CHILDREN'S HOSPITAL
OF ORANGE COUNTY
455 S. Main St.
Orange, CA 92668-3874

TOWER II

MECHANICAL DETAILS -
PIPE SUPPORT DETAILS

M10.06

MEDIUM TO LOW PRESSURE PRV STATION #2, 3 AND 4 PIPING DETAIL

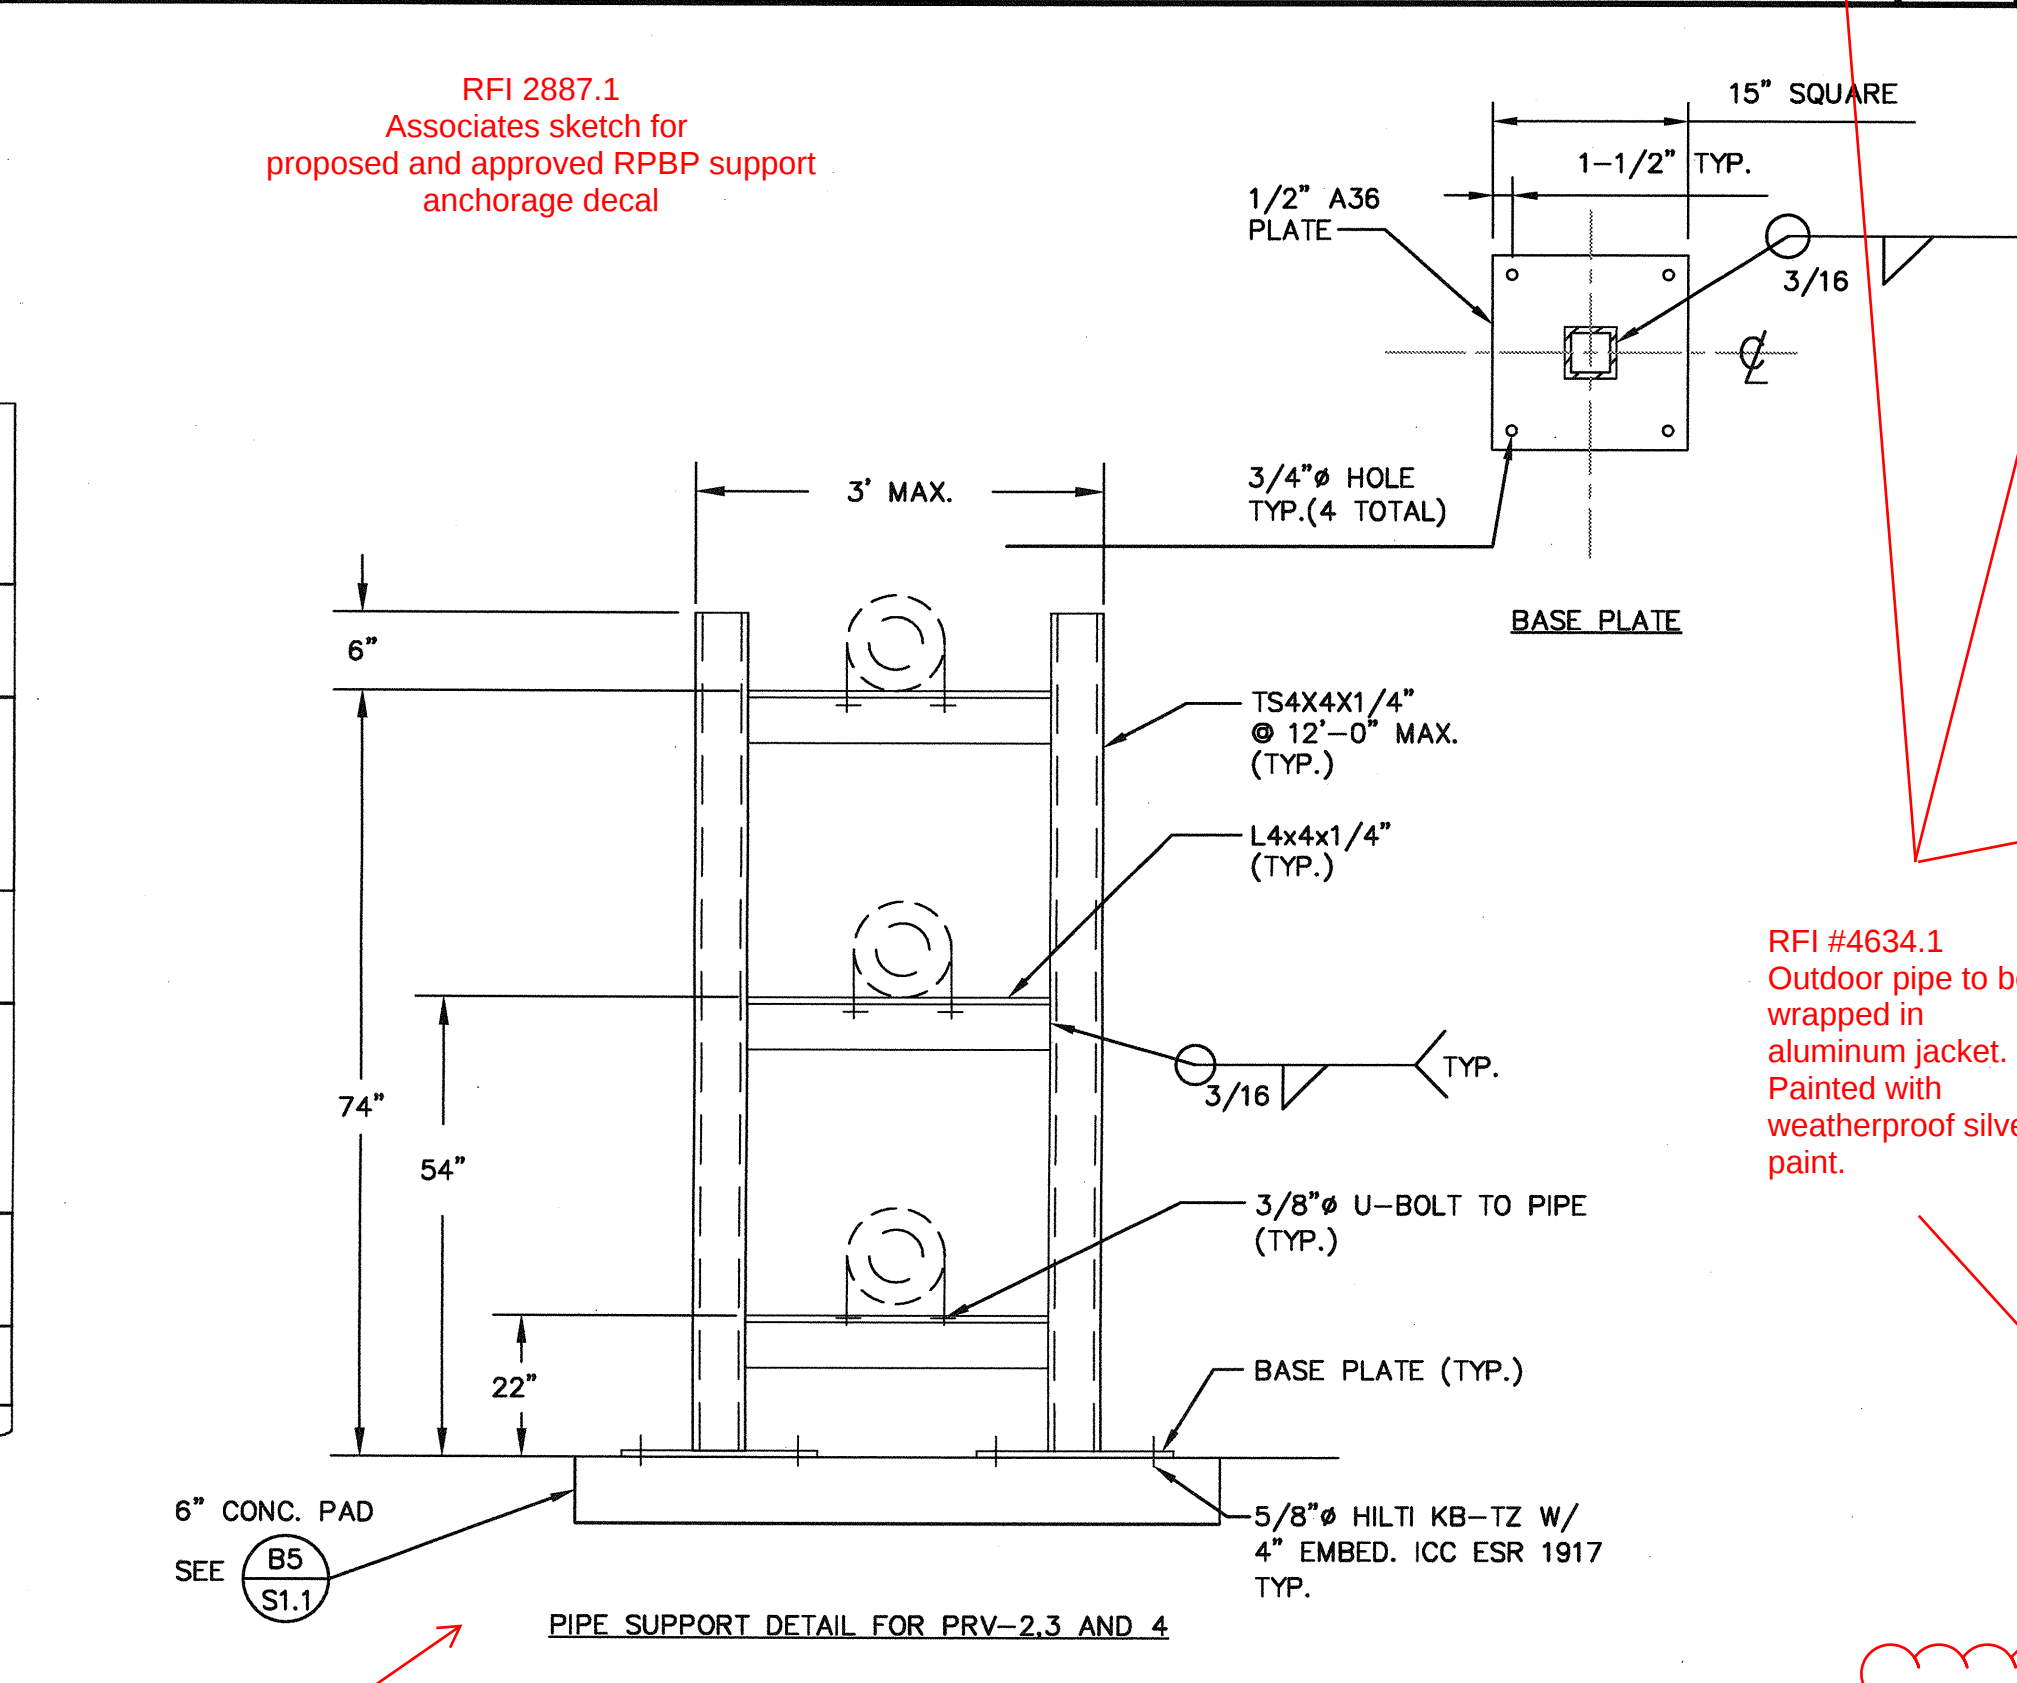
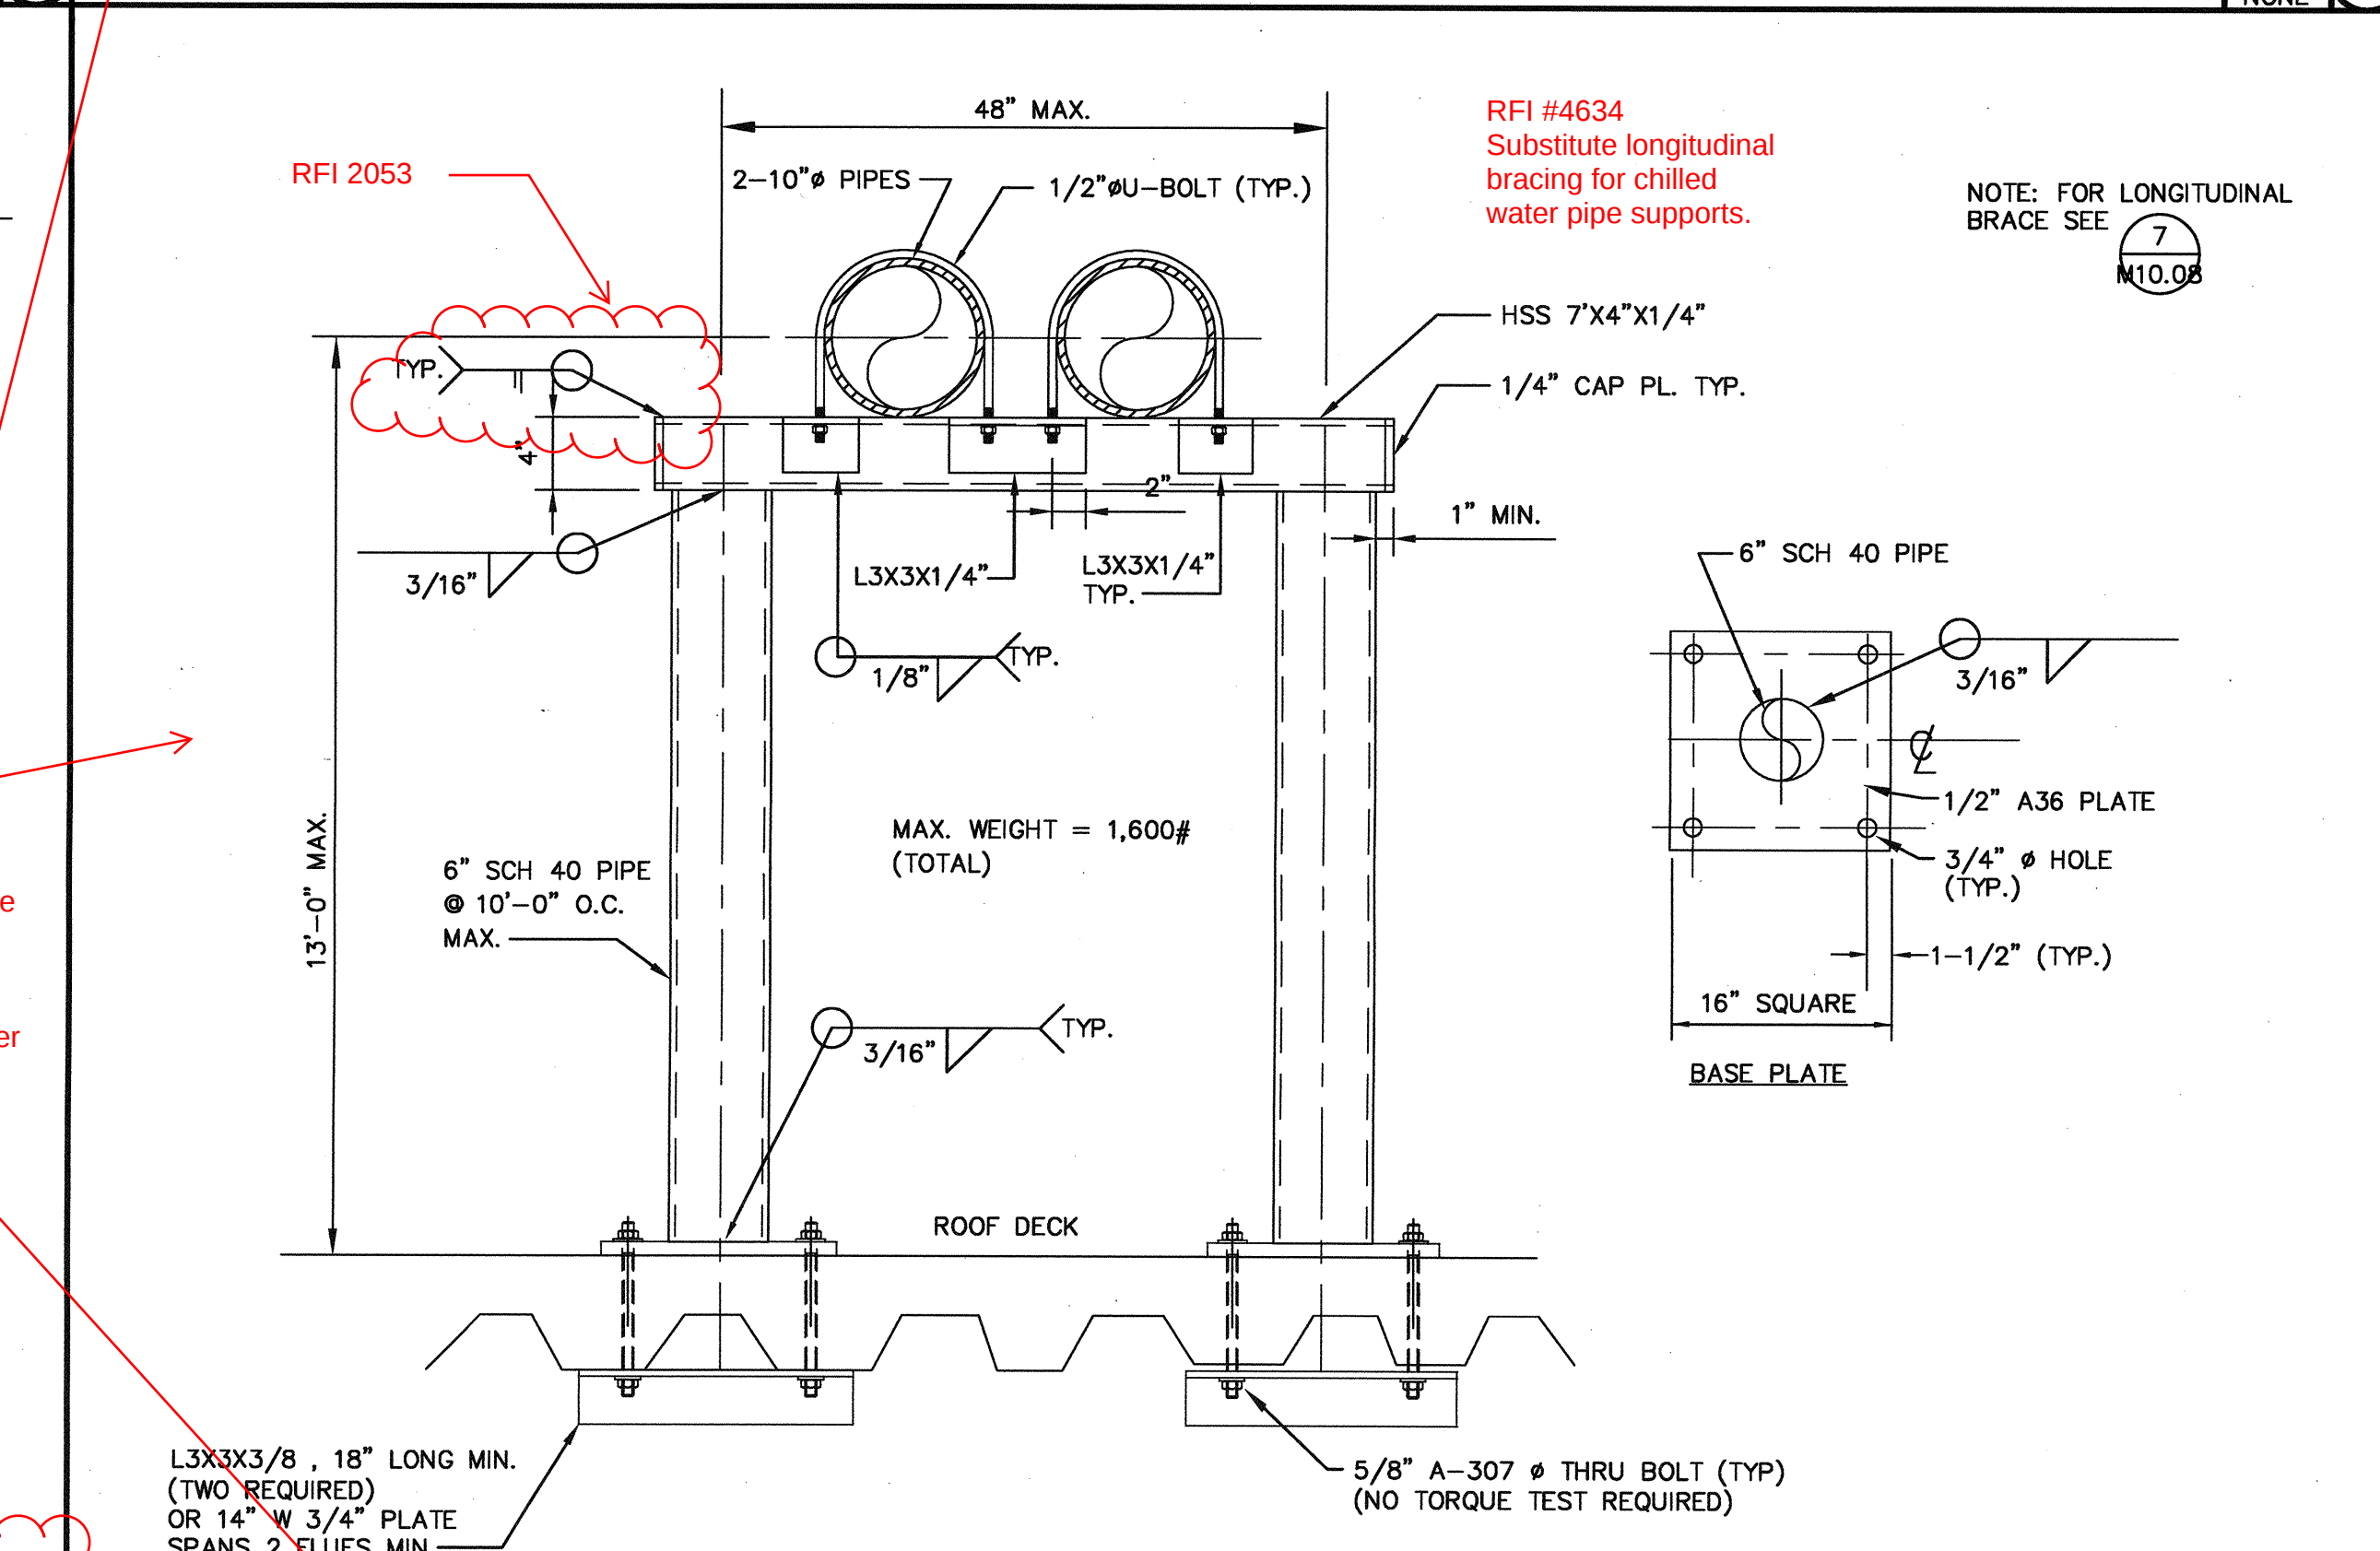
RFI #3944

Temperature controls conduit
acceptable to attach to pipe and duct
supports on roof.
